Addendum No. 2
October 16, 2023

Project: **Harrisburg South Middle School Theatre Addition**
Harrisburg, South Dakota
Architecture Incorporated Project #3024

Scope of this Addendum:

HARRISBURG SOUTH MS THEATRE ADDN
DETAILS - FOUNDATION

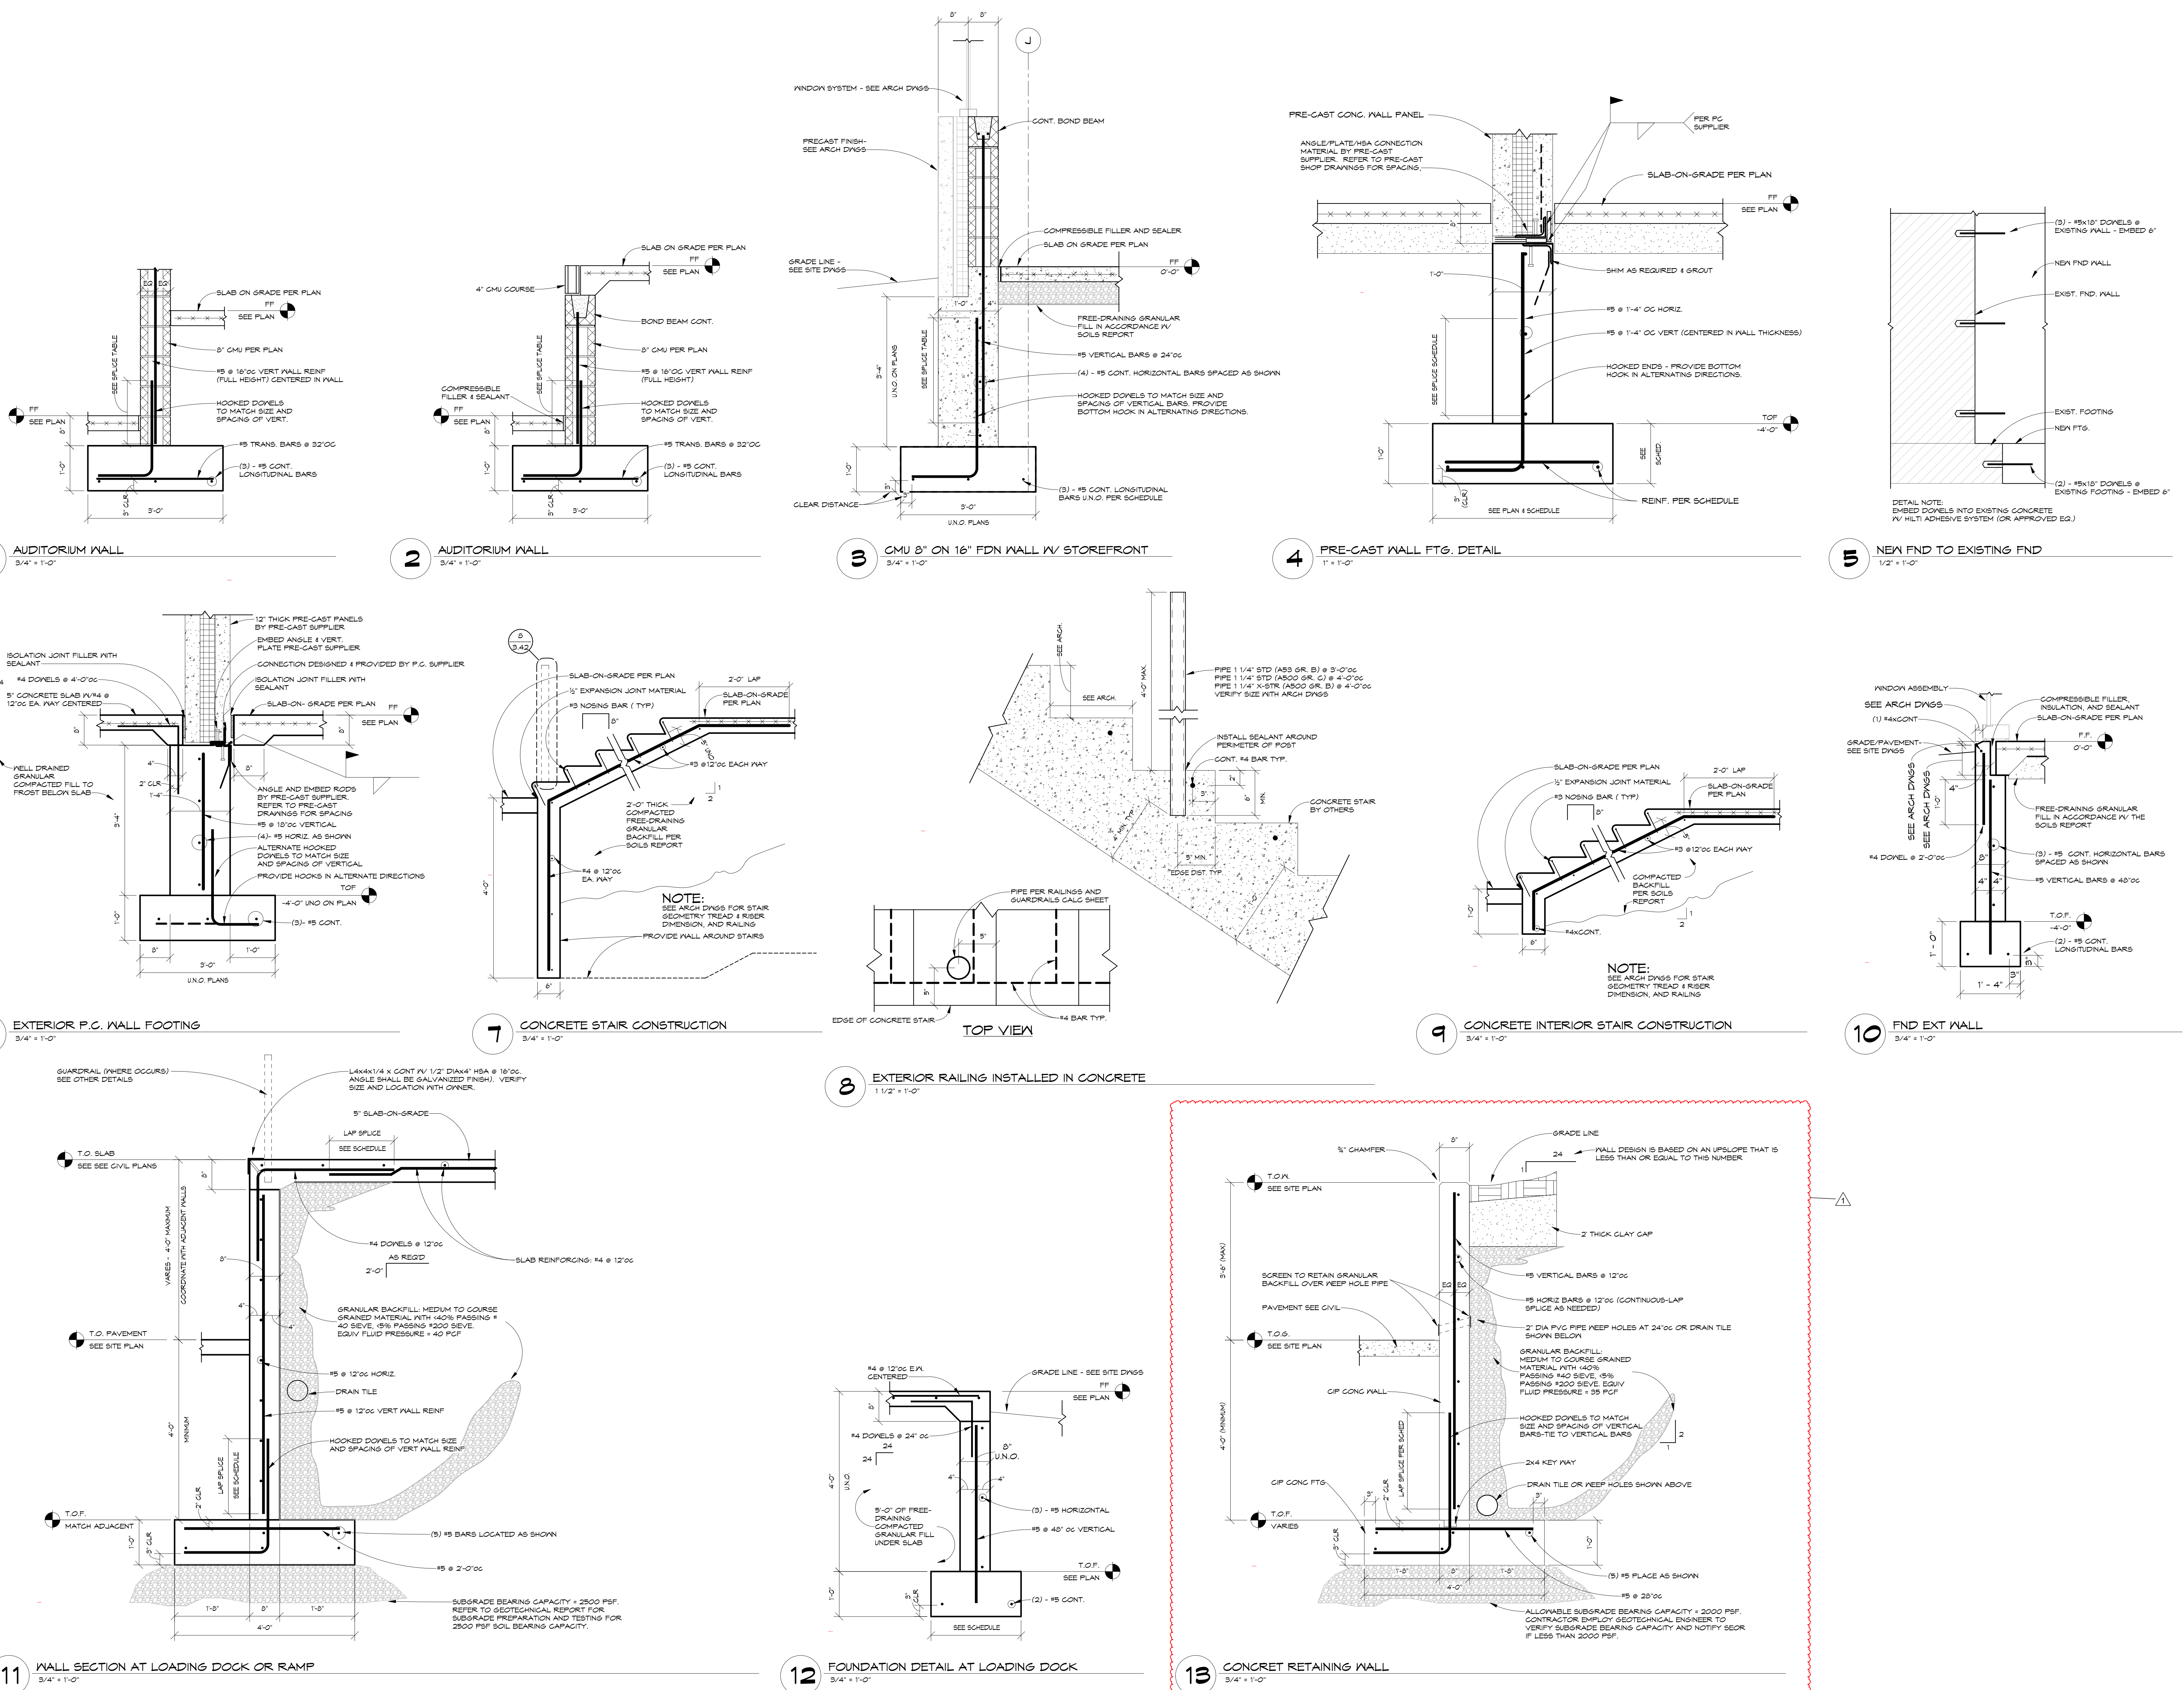
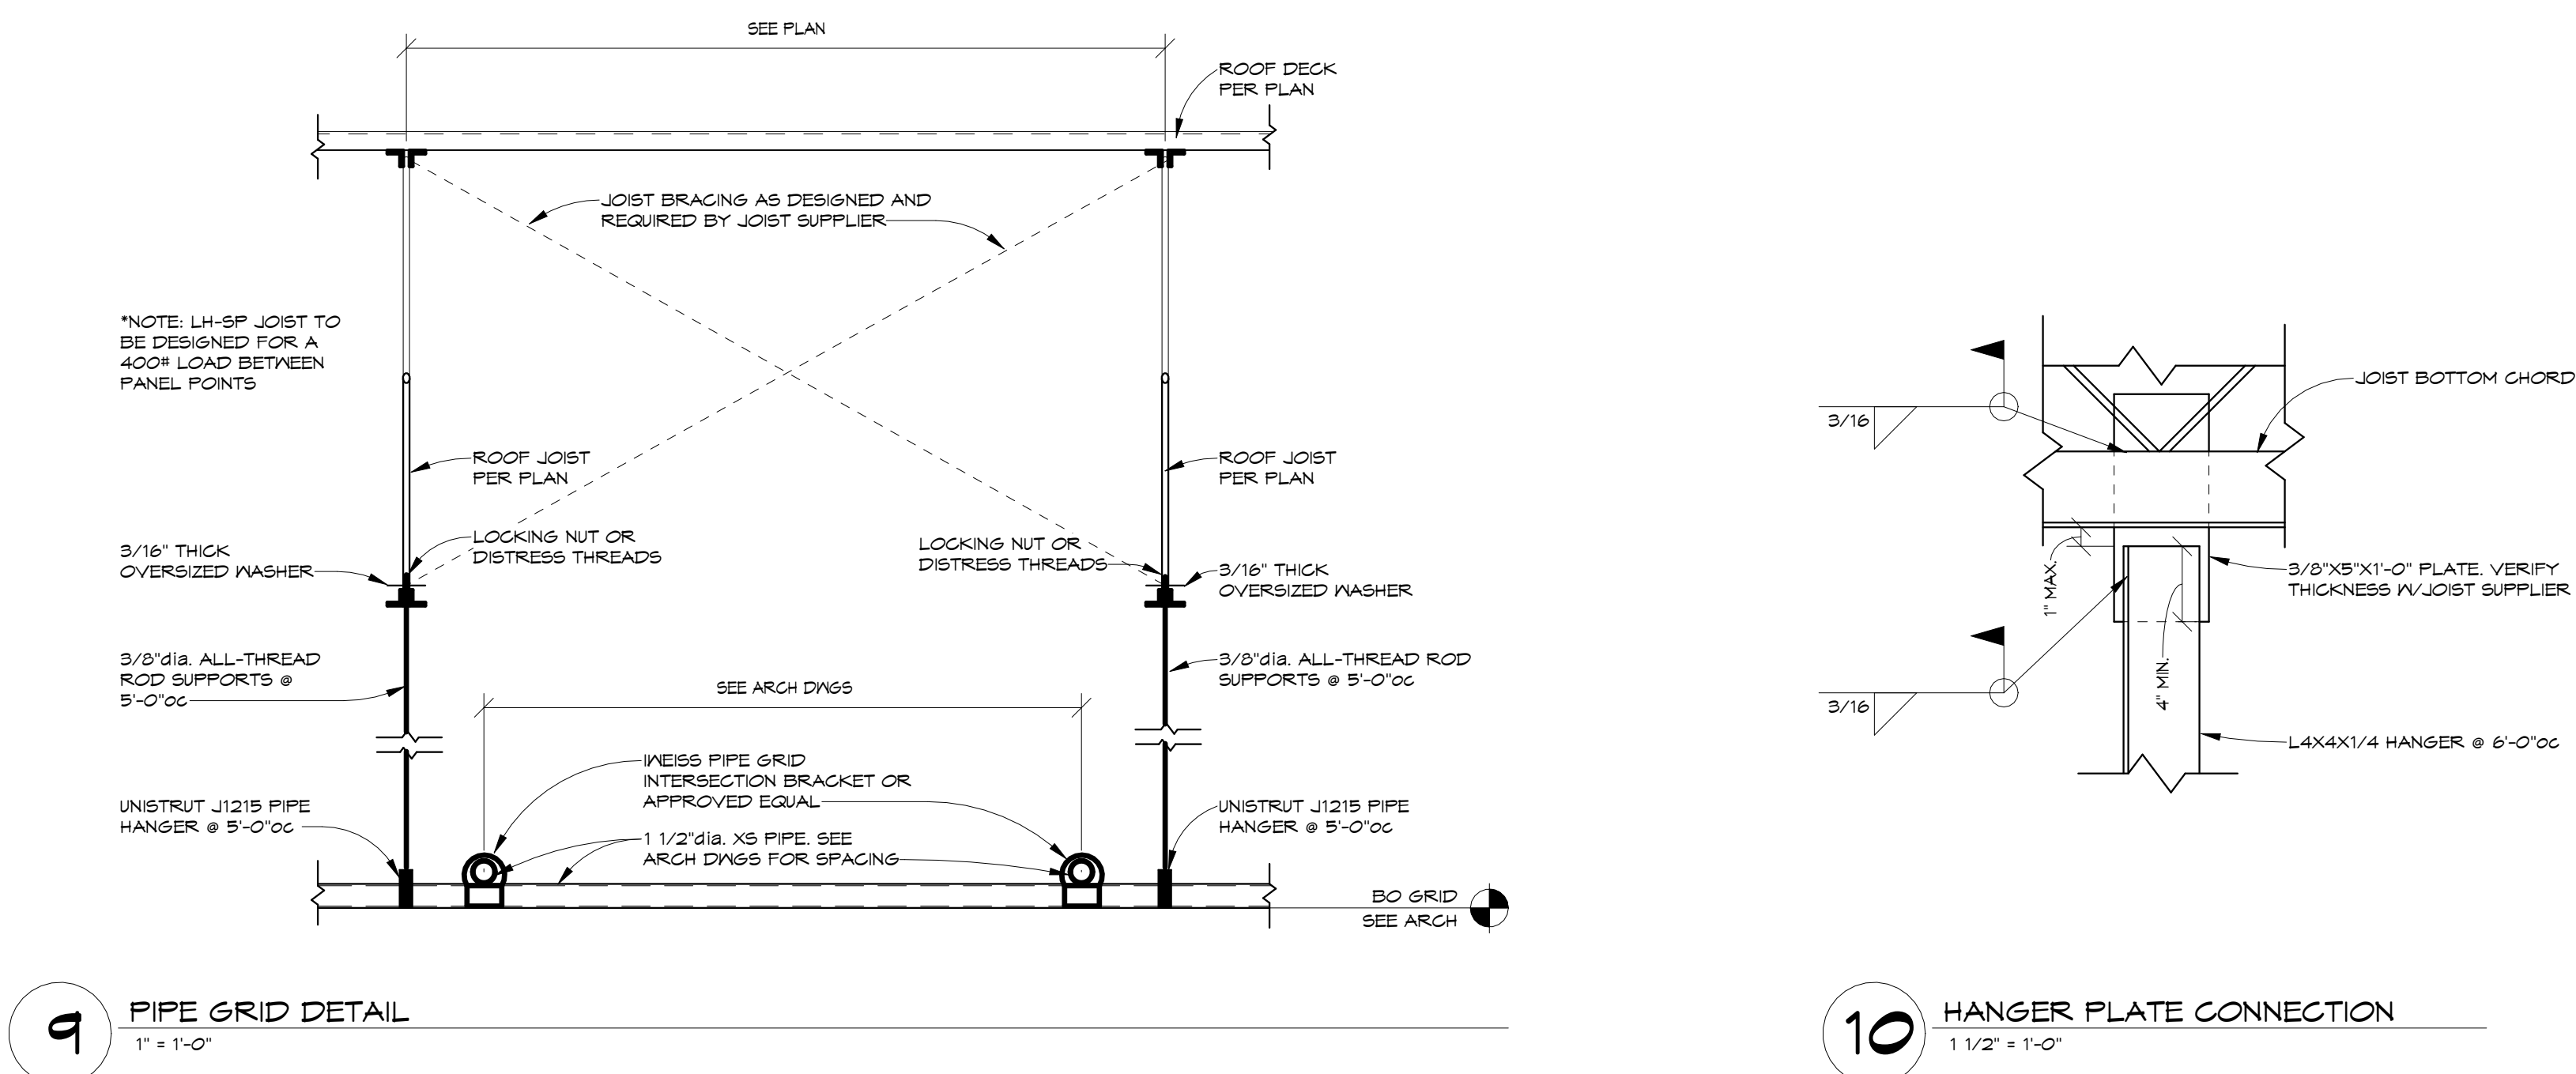
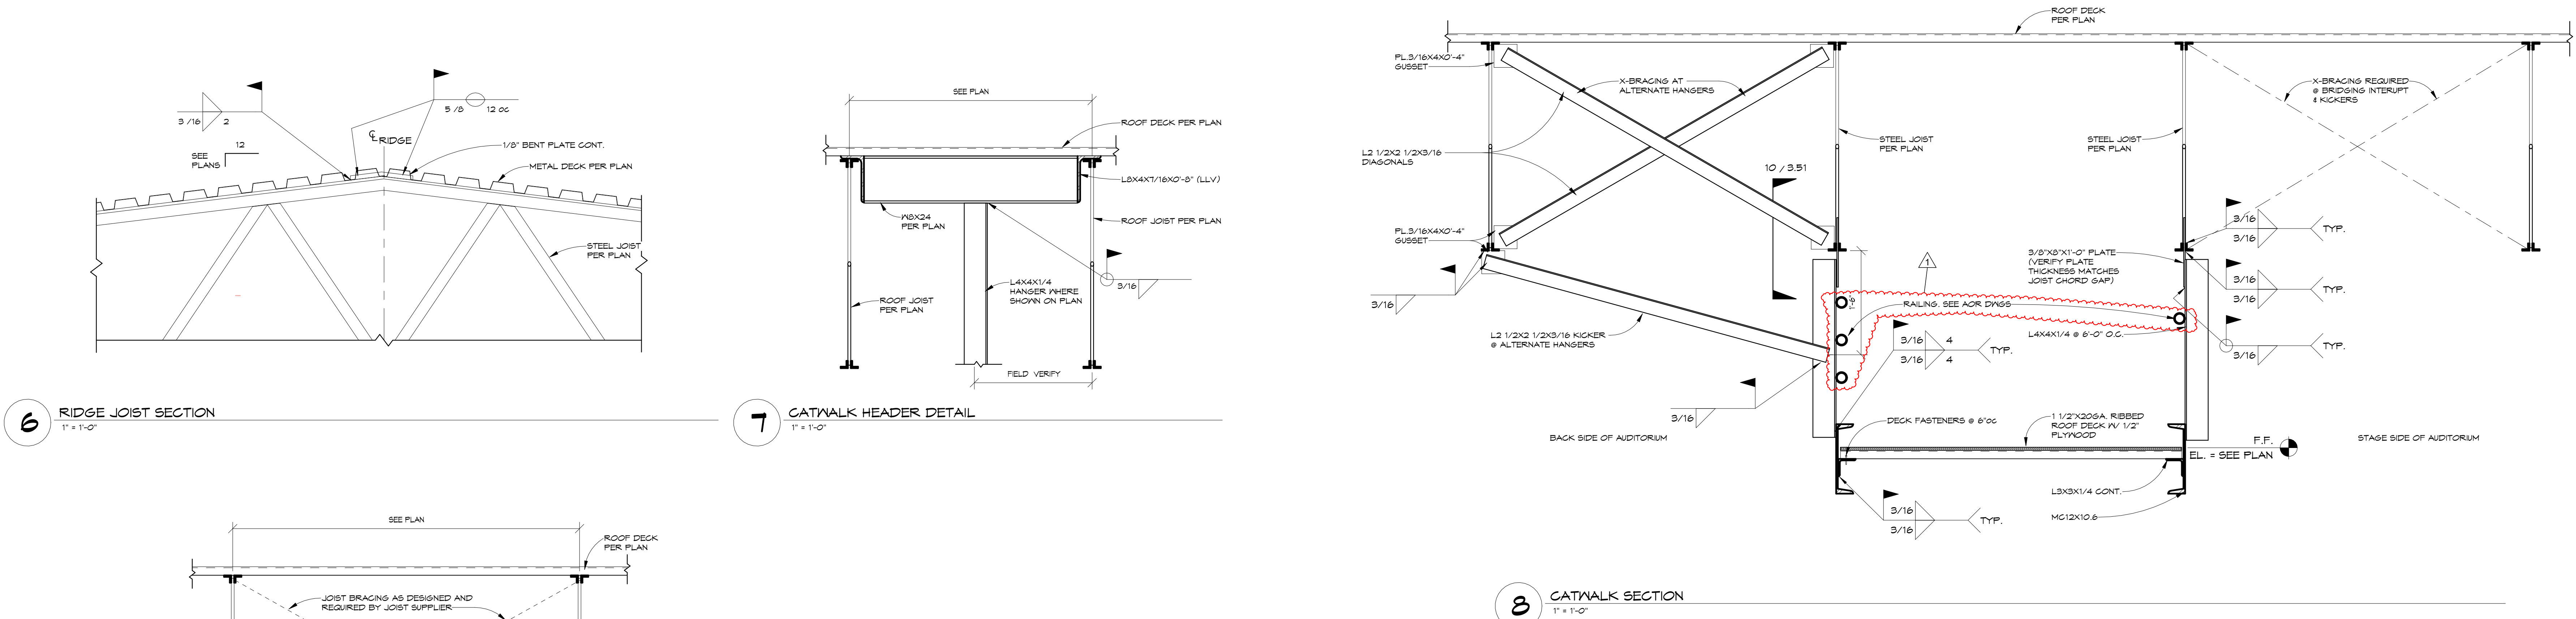
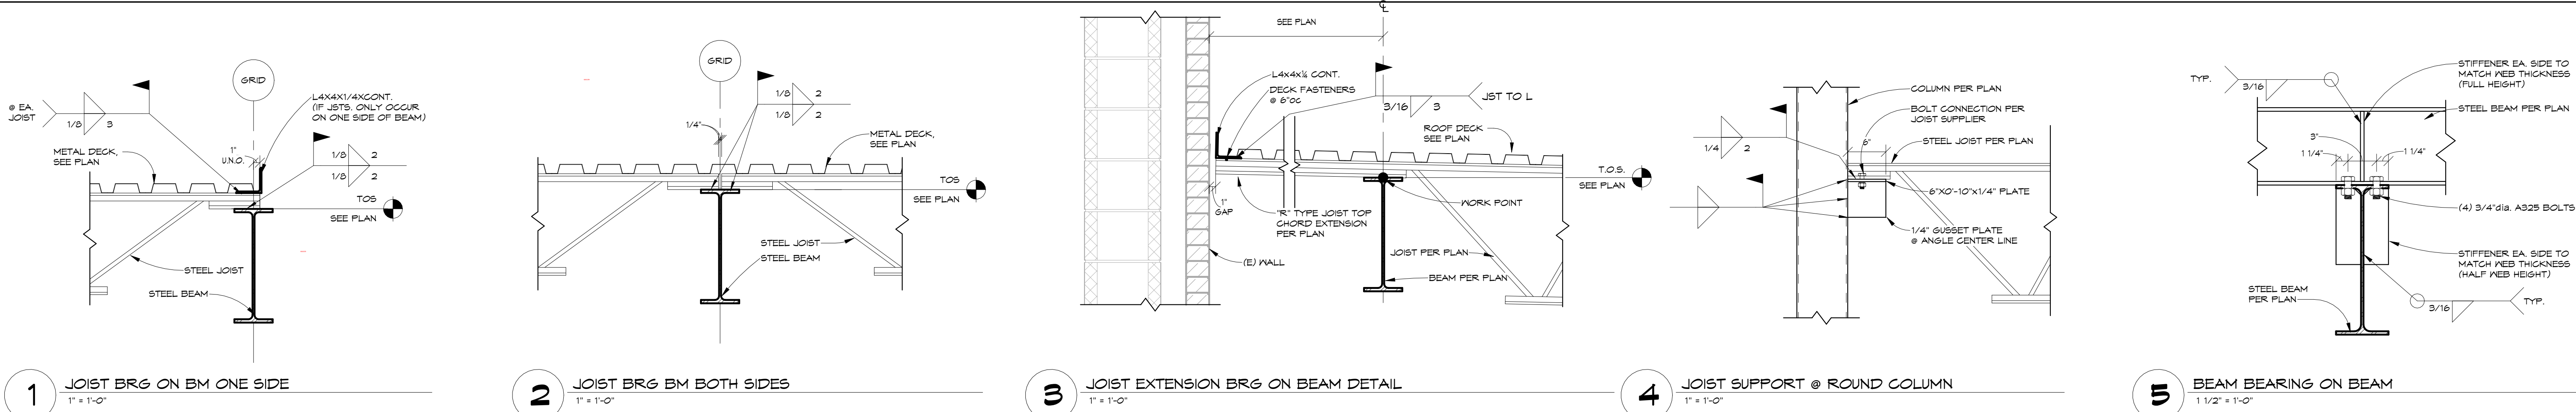
- a) Add site retaining wall detail 13 per revised sheet.
